**OIL & GAS CONSERVATION DIVISION**  
1220 South St. Francis Dr.  
Santa Fe, NM 87505

WELL API NO. 30-25-26796
5. Indicate Type of Lease STATE <input checked="" type="checkbox"/> FEE <input type="checkbox"/>
6. State Oil & Gas Lease No. 307068
7. Lease Name or Unit Agreement Name Bobbi State Waterflood Unit
8. Well Number 2
9. OGRID Number 232611
10. Pool name or Wildcat Arkansas Junction SA

**SUNDRY NOTICES AND REPORTS ON WELLS**  
(DO NOT USE THIS FORM FOR PROPOSALS TO DRILL OR TO DEEPEN OR PLUG BACK TO A DIFFERENT RESERVOIR. USE "APPLICATION FOR PERMIT" (FORM C-101) FOR SUCH PROPOSALS.)

2. Name of Operator  
SUNDOWN ENERGY LP

## WELL DATA SHEET

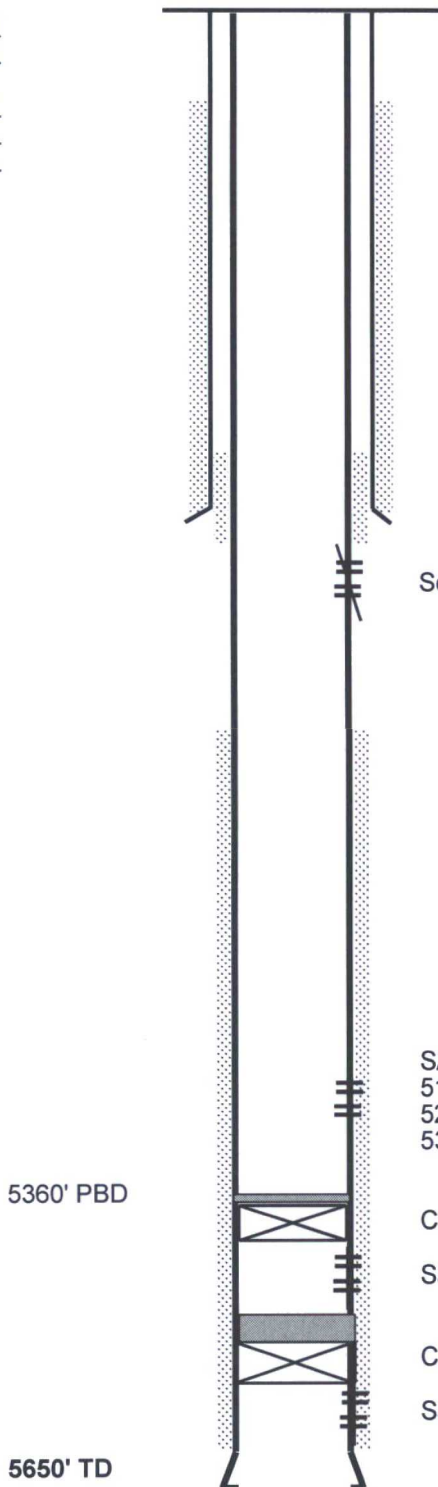
1. MI RU Well service Rig
  2. POOH w/ production equipment
  3. RIH & drill out CIBPs @ 5335' & 5510'
  4. Clean out well to TD (5650')
  5. RBIH w/ production equipment.
  6. Return to production.
- PERFS: 5152' – 55156'; 5246' – 5248', 5352' - 5355'  
5476-86' & 5523-35'
